Town of Arlington, MA Redevelopment Board

Agenda & Meeting Notice September 9, 2024

2. Public Hearing: Docket #3816, 5-7 Belknap Street

3. Public Hearing: Docket #3633, 1500 Massachusetts Avenue

Shadows – angle 1

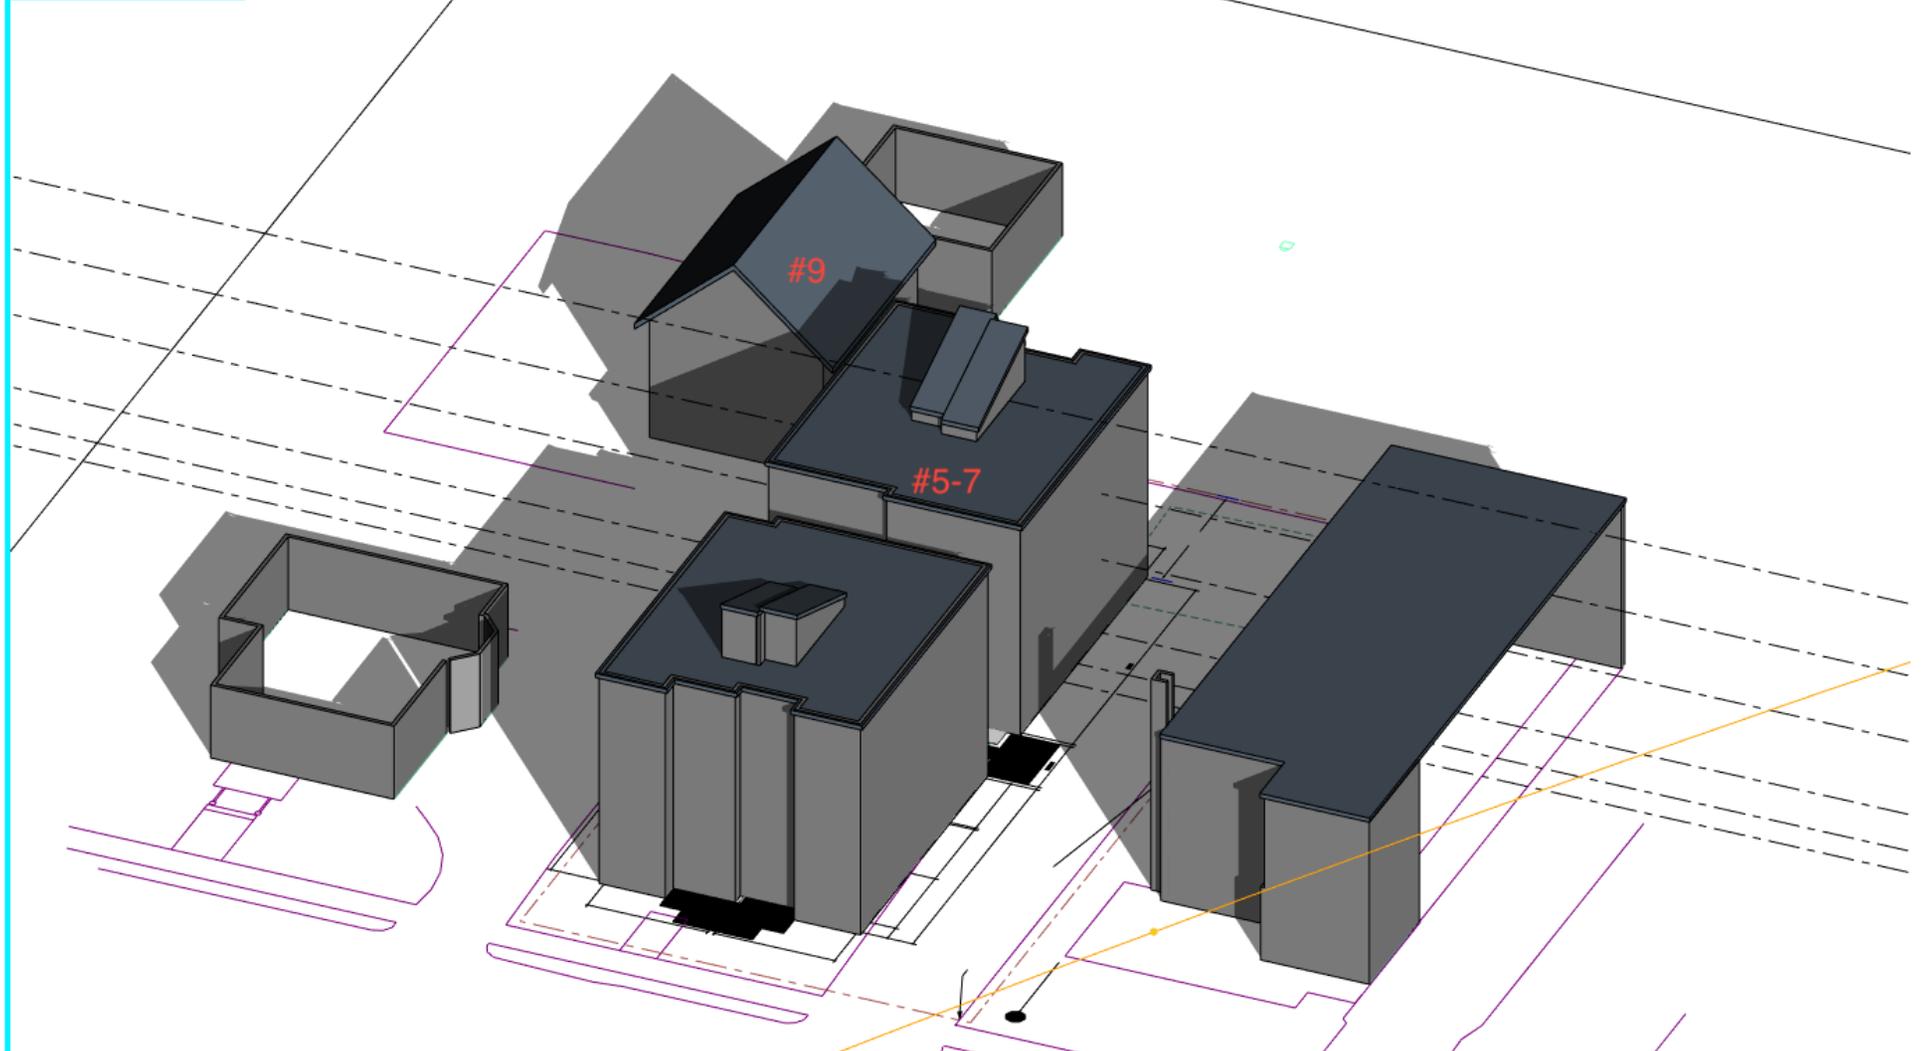
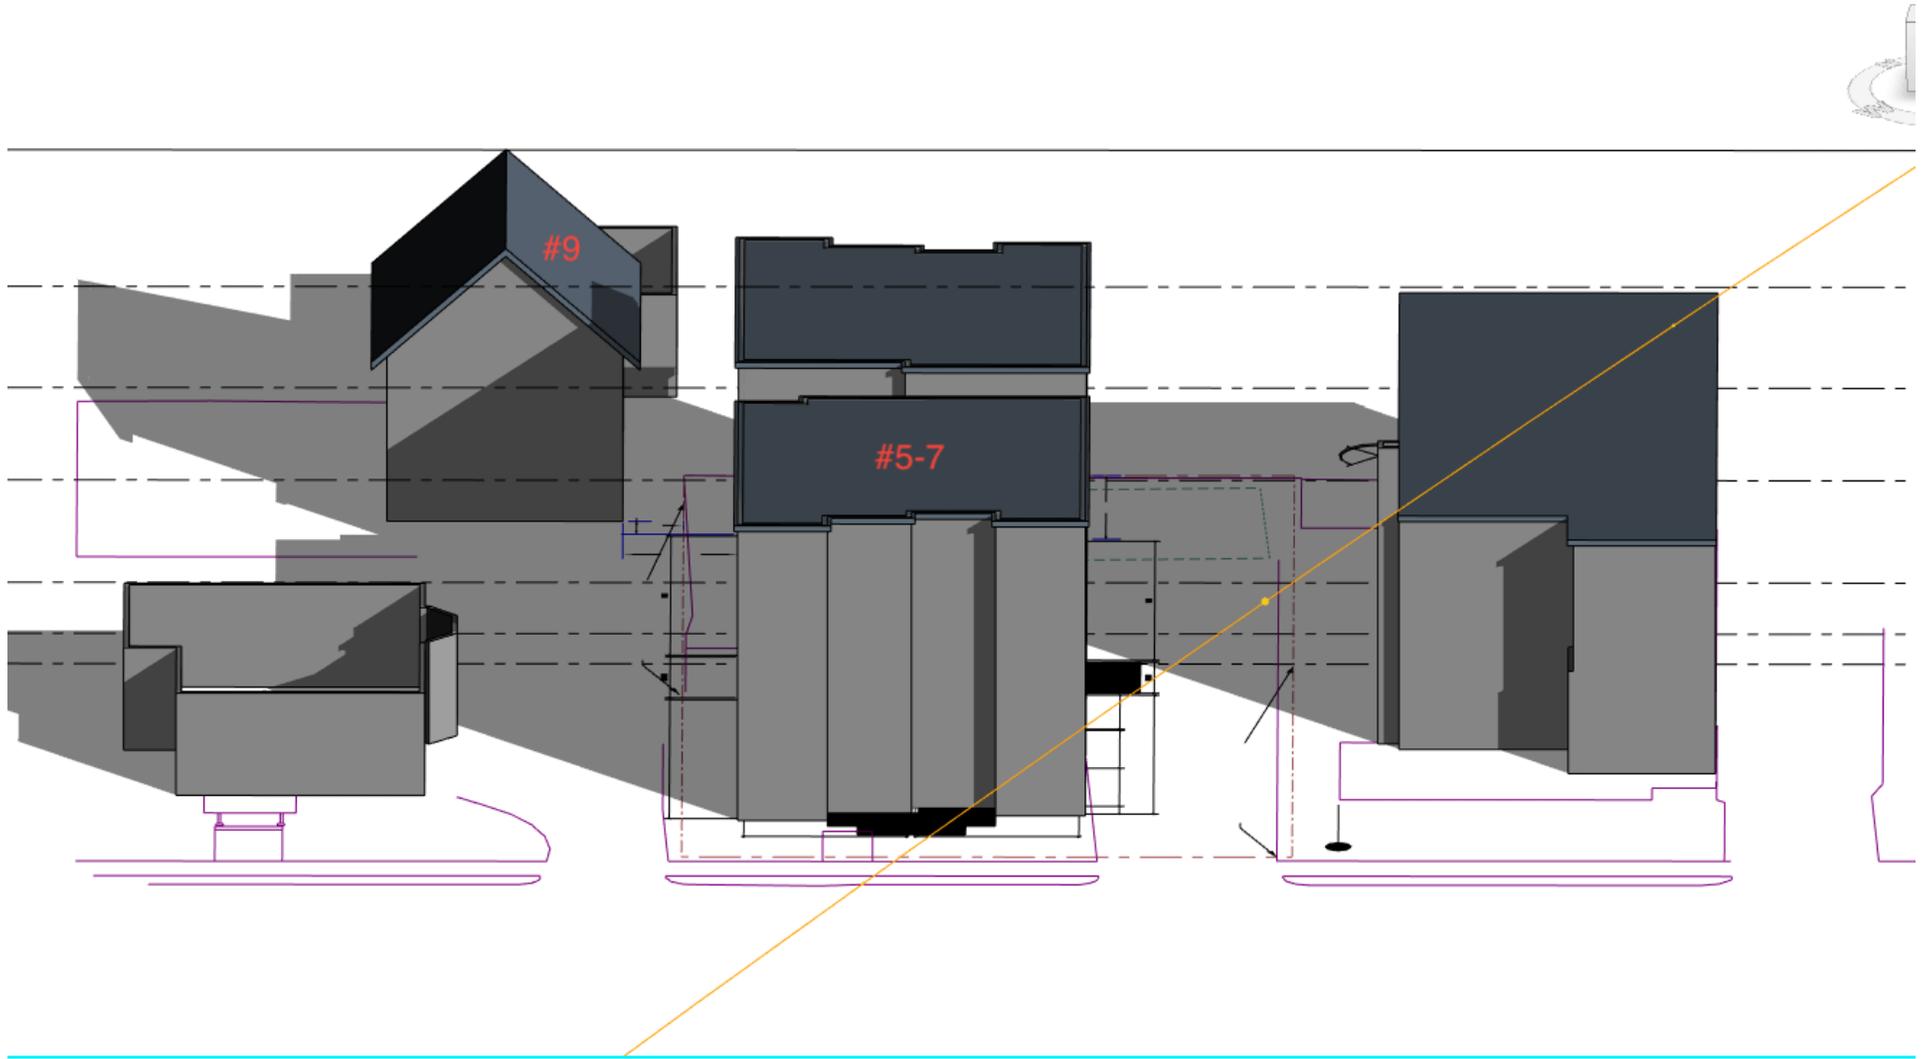
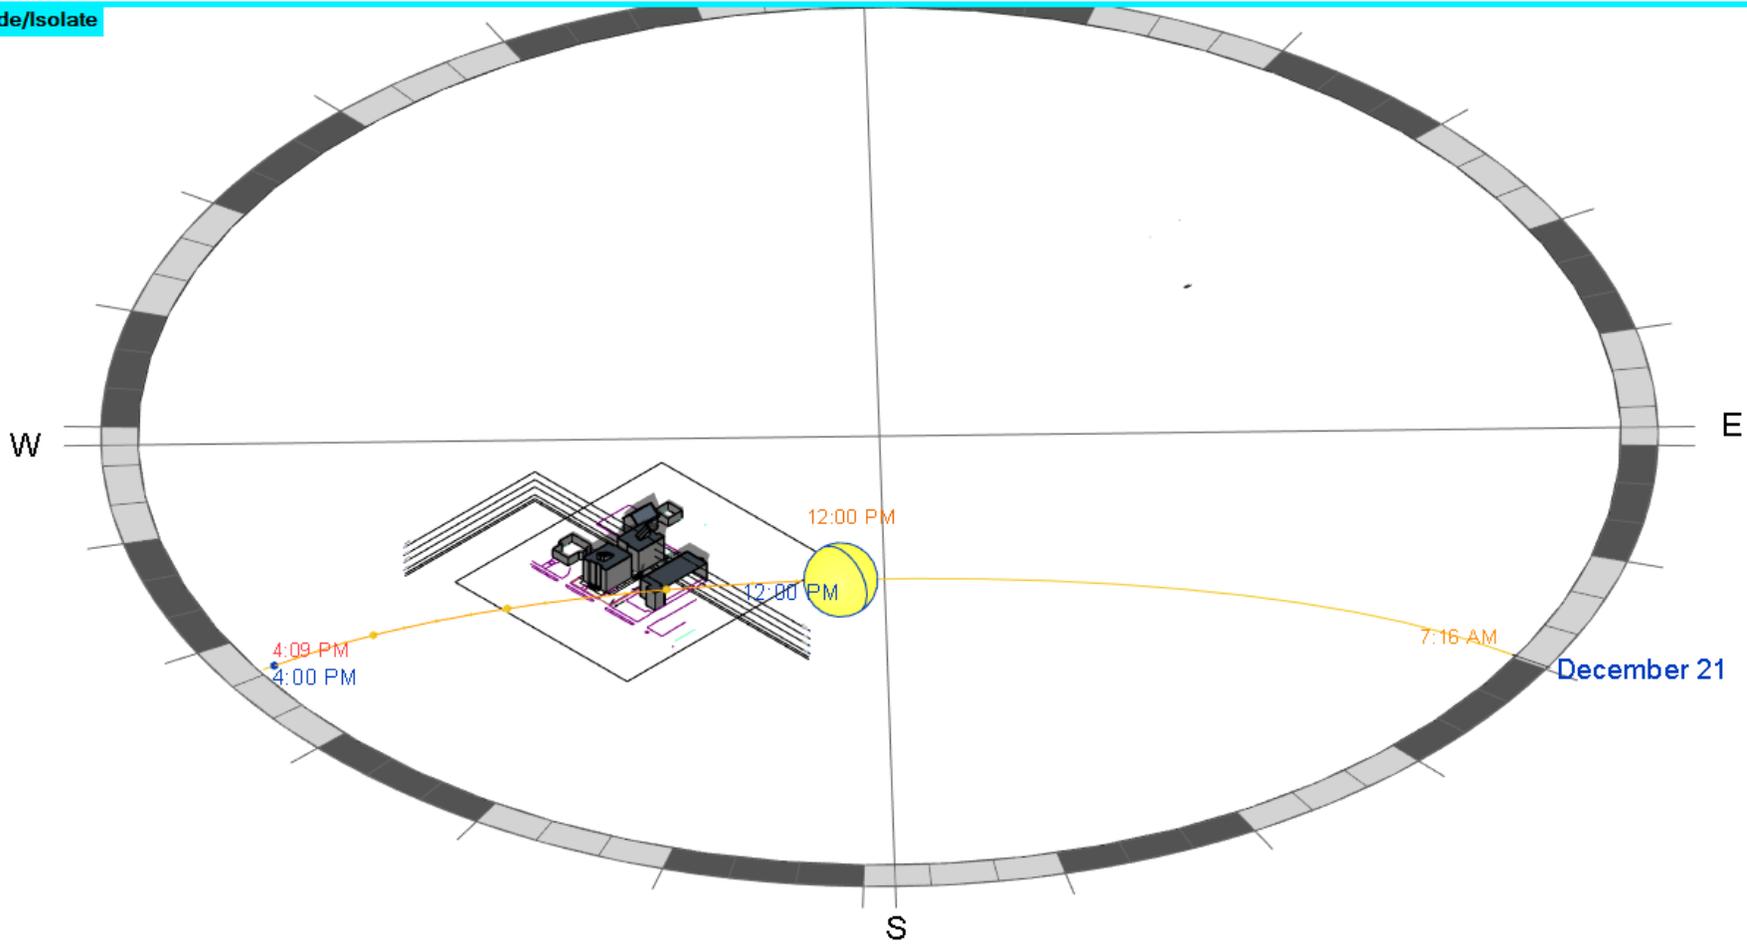
Our specific concerns are around the substantial shading this building will have over the front of our home, and the loss of privacy (for us and the tenants of the proposed building) as the new structure is extending 25' back and pushing out on the side to be 10' from our house. In one design Collins shared via email last week there's even a second-floor balcony proposed 10' from our children's bedroom window. Someone out there smoking or having loud conversation at bedtime would be very disruptive.

Attached are images from research that we commissioned: a shade study, and an overlay of the developer's plan onto the lot. We have shared these, along with our concerns with Collins.

1 Proposed First Floor Plans
Scale: 1/4" = 1'-0"

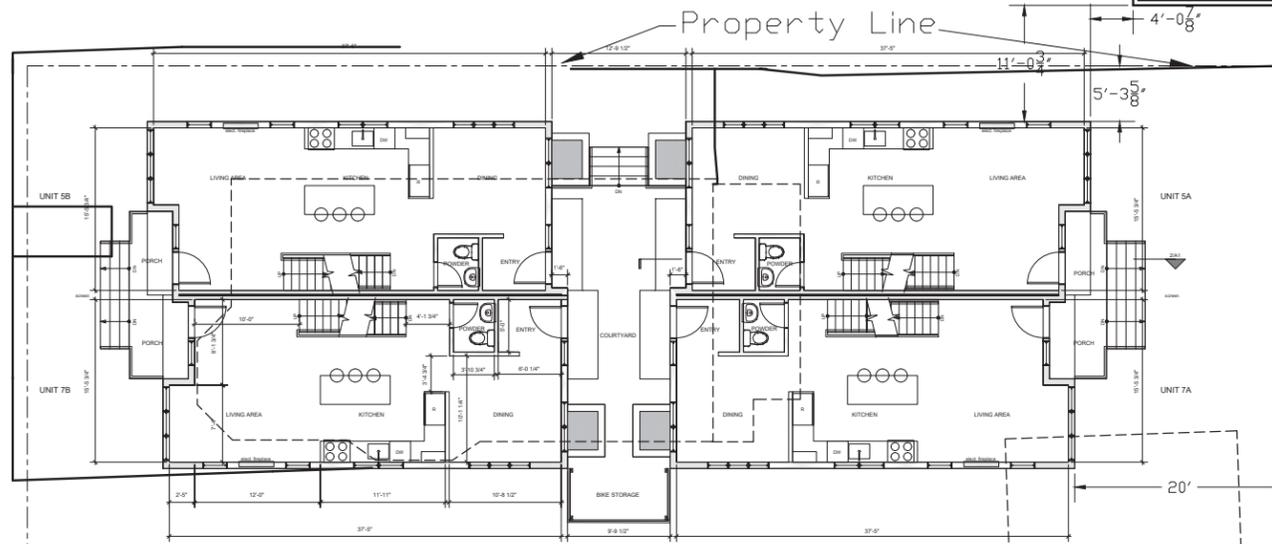
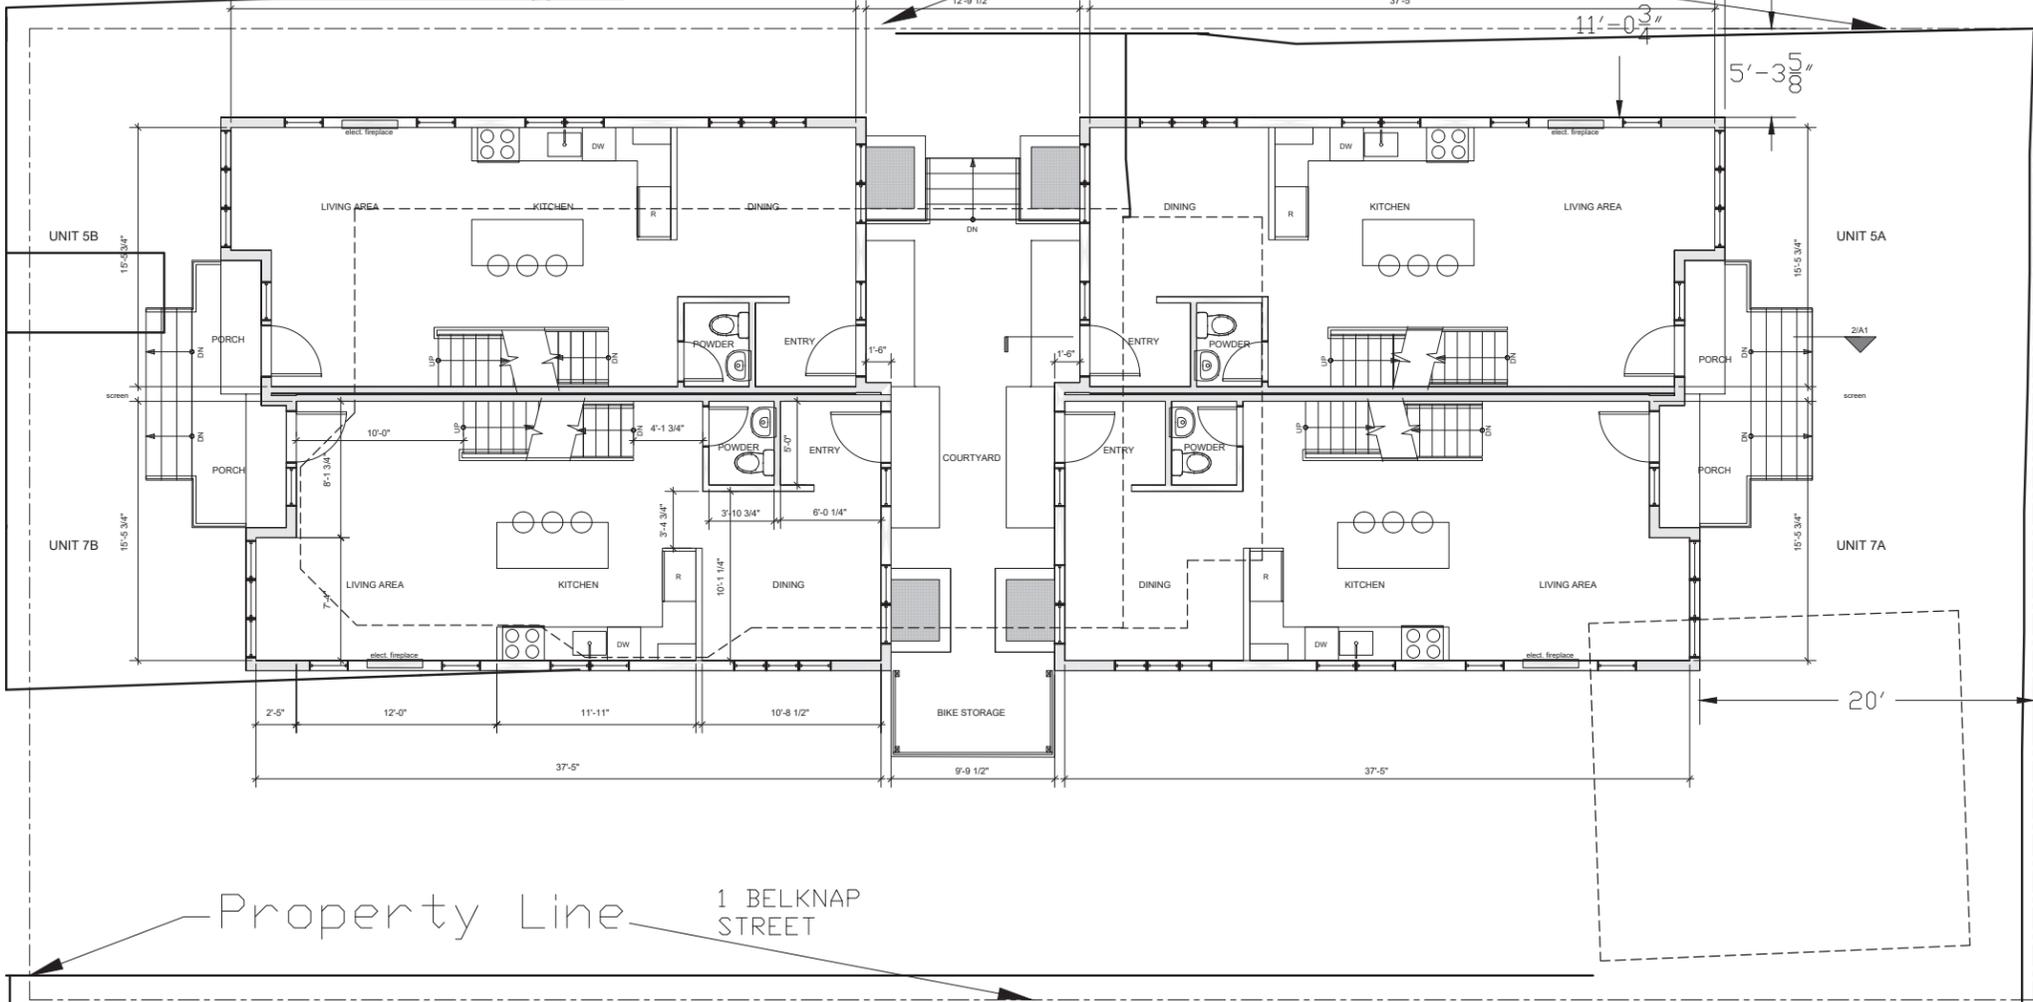
We feel that tearing down an affordable two-family home and eliminating the existing green space to build four substantially more expensive units is in opposition to the spirit of retaining the character of the neighborhood and creating housing that my daughter's first grade teacher could afford. We hope the plan is not approved without substantial changes to limit the negative impact on shading, privacy, and greenspace.
